# UNITED STATES PATENT AND TRADEMARK OFFICE

10/595,063

<b>Office Action Summary</b>	<b>Application No.</b> 10/595,063	<b>Applicant(s)</b> BUSE, HENRY	
	<b>Examiner</b> CHUN CHEUNG	<b>Art Unit</b> 3728

## DETAILED ACTION

Fig. 5

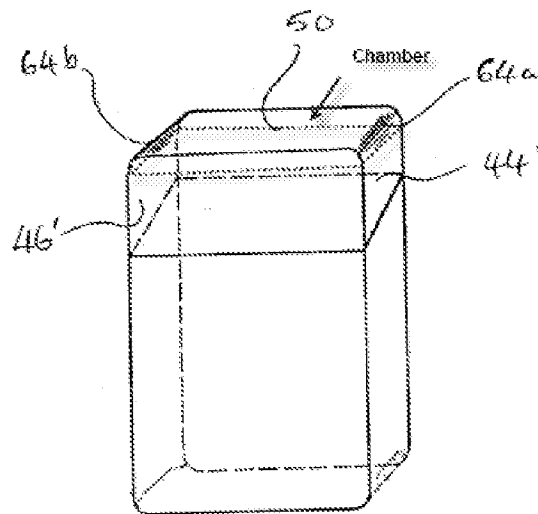
As to claim 34, Singer discloses a hinged-lid box, for a cigarette block wrapped in an inner blank as pack contents (page 1, lines 9-10), comprising a longitudinally extending box part (Figure 5), lid and collar, the box part having a relatively wide box front wall

(10), a corresponding box rear wall (12), relatively narrow box side walls (14, 16) and a base wall (18), and the lid having a relatively wide lid front wall, a corresponding lid rear wall, relatively narrow lid side walls and an end wall (Figure 5), characterized by the following features: a) the lid is connected in a pivotable manner to the box part in a region of the lid rear wall, and to the box rear wall, by a transversely directed linear articulation (Figure 5), b) formed above or beneath the cigarette block is a free chamber (Figure above, if the width of the cigarette block is the width of the cigarette pack, the rounded portion will create a chamber) which is bounded in an outward direction in a region of the lid at least by the end wall, the lid front wall and the lid rear wall or in a region of the box part below the pack contents by the base wall, the box front wall and the box rear wall, and is bounded in an inner direction by the cigarette block, c) the chamber is arranged symmetrically in relation to a transverse, central vertical plane of the box (Figure 5), and d) the end wall or base wall has an arcuate configuration, running from one lid side wall to the other lid side wall or from one box side wall to the other box side wall. However, Singer does not disclose a collar attached to the cigarette box, and does not disclose the arcuate angle is predominantly arcuate configuration. Nevertheless, It would have been obvious to a person having ordinary skill in the art at the time of the invention to put a collar inside the cigarette pack box is well-known and also the predominantly arcuate angle is generally recognized as being within the level of ordinary skill in the art, absent any showing of unexpected results. *In re Dailey et al.*, 149 USPQ 47.

As to claim 38, Singer discloses the end wall and the base wall have rounded side section (Figure 5) and a planer, transversely directed central section (50), with the side sections being of at least partially elliptical design or being parts of ellipses, the side section adjoining the side walls with a relatively pronounced curvature and merging into a horizontal central section (50)

Fig. 4

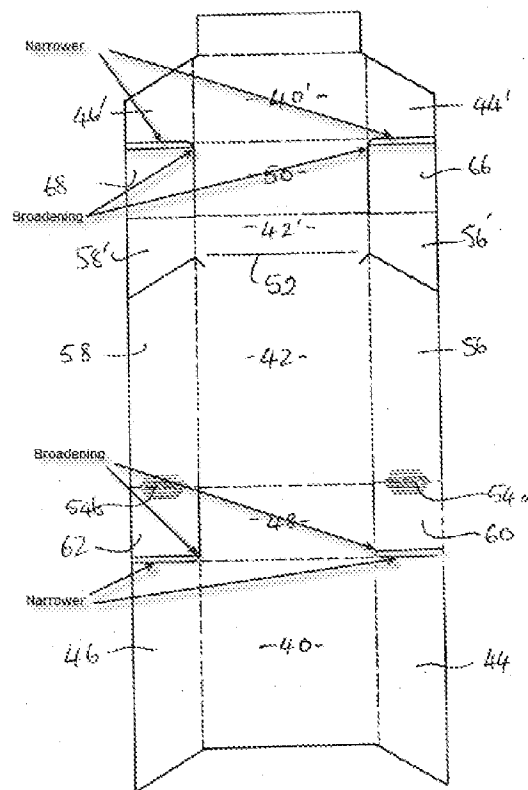
As to claim 36, Singer discloses lateral sub-regions of the end wall and the base wall are continuations of the lid side walls and the box side walls, and are extensions, namely end tabs (56, 58), of inner lid side tabs and the box side tabs (Figure 4).

As to claim 37, Singer discloses the end wall and the base wall are of at least double layered design in a central section, by virtue of a crosspiece (50) being arranged on the outside of the end wall or base wall, with end regions of the end tabs being fastened on an inner side of the crosspiece (Figure 4).

As to claim 40, Singer discloses the end wall and base wall, in sub-regions outside the crosspiece , are supported on a free edge of the lid front wall and the lid rear wall or box front wall and box rear wall, by way of a broadening provided on the end tabs (see Figure below).

As to claim 41, Singer discloses all the limitation in claim 34 above, but does not disclose the chamber is formed only in the region of the end wall, above the cigarette block, by a corresponding design of the end wall and of the base wall is designed in a planar manner in order for the cigarette block to butt against the inside of the base wall. However, the size of the chamber above the cigarette block and design to butt against the inside of the base wall are an obvious matter of design choice, for example, as to Figure 5 above, the cigarette block can be design below the blue line as drawn in above Figure, so the chamber is above the cigarette block.

free peripheral edges of the lid front wall and lid rear wall or against free peripheral edges of the box front wall and box rear wall in a region of a broadening of the end wall or base wall (Figure 4 above).
